# Lower Thames Crossing

## 9.158 Applicant's submissions on construction impacts and management at Asda roundabout

Planning Inspectorate Scheme Ref: TR010032  
Examination Document Ref: TR010032/EXAM/9.158

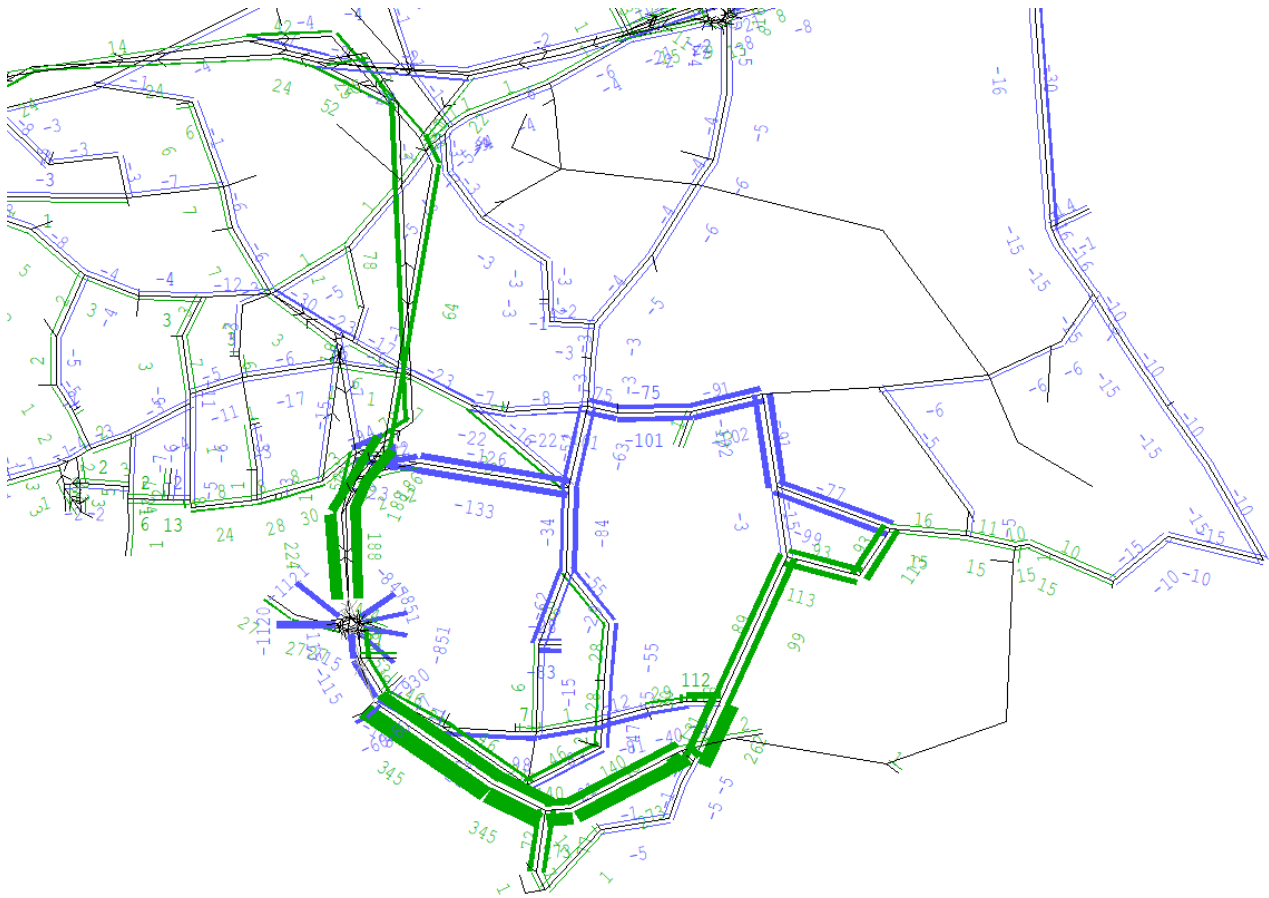
- 6.3.13 The Applicant considers that the construction of the proposed mitigation scheme would lead to substantially more disruption to the operation of Asda roundabout and the functioning of the Port than any works proposed in the construction of the A122 Lower Thames Crossing.
- 6.3.14 While the Applicant has a significant number of operational controls that can be applied to the Project, works of this nature, directly on such a critical piece of infrastructure, could only be safely undertaken with substantial disruption to the flow of traffic.

- 6.3.15 The Applicant also considers that the proposed mitigation would be disproportionate, and that it is unnecessary to address the impacts during the construction phase, as operational controls, as provided for in the oTMPfC [REP5-056], would be better suited.

### Plate 6.2 Change in flow in phase 6, AM peak, amended network to include PoTLL mitigation scheme

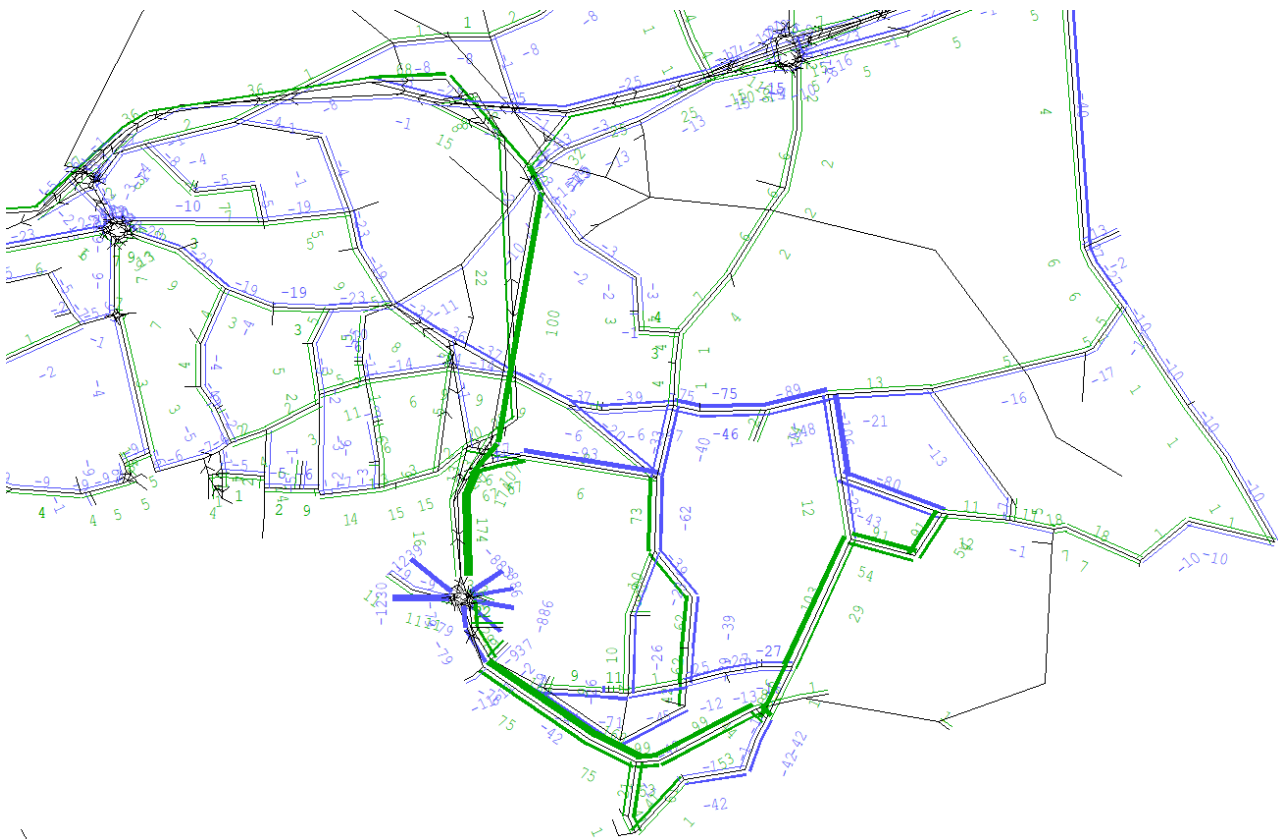
- 6.3.20 Plate 6.1 and Plate 6.2 show the forecast change in flows in comparison with the Do Minimum scenario in the AM peak for construction traffic phases 1 and 6 respectively. It should be noted that around the Asda roundabout itself, because of coding changes between the scenarios, the flow changes are not correct as the model does not have equivalent links to undertake the comparison.

Plate A.1 PoTLL Asda roundabout mitigation scheme

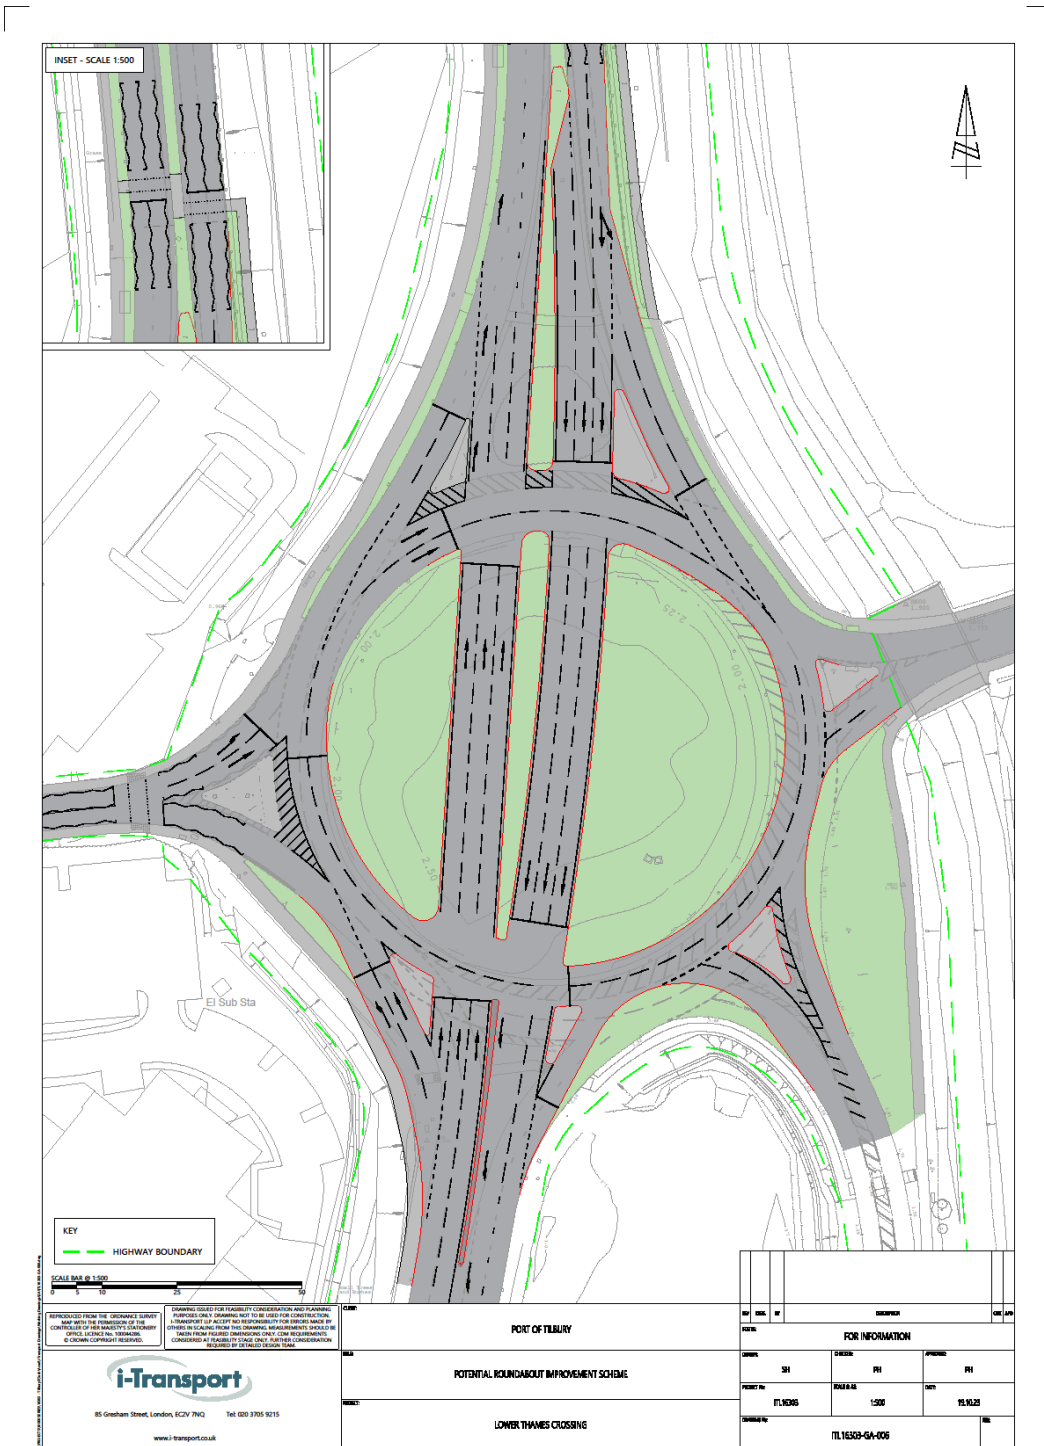
6.3.1 The Applicant's initial comments in response to the proposed PoTLL scheme are as follows.

6.3.2 The Applicant has only received a PDF drawing of the PoTLL proposals, and as such has been unable to undertake a full design check of the proposals.

6.3.4 The Applicant's preliminary view is that the proposal is broadly compliant with standards, although as noted above, this view has been reached without access to a CAD drawing of the proposals (which would allow accurate measurements to be taken), a road safety audit and any changes that may be required following consideration of other constraints (such as the impact on existing utilities).

- i. To provide a fully signalised roundabout, an extensive network of ducting would need to be installed including sections which would require carriageway crossings.

- ii. To provide a safe working environment, lane closures would be required for between three and six months which would reduce capacity and increase journey times on the roundabout and its approaches.

- 6.3.12 The Applicant does not consider that PoTLL have presented a clear case for their mitigation scheme, as assessment of the existing layout of the roundabout in neither the Do Minimum (without the construction of the Project) or the Do Something (with the construction of the Project, but without their mitigation scheme) have been presented.
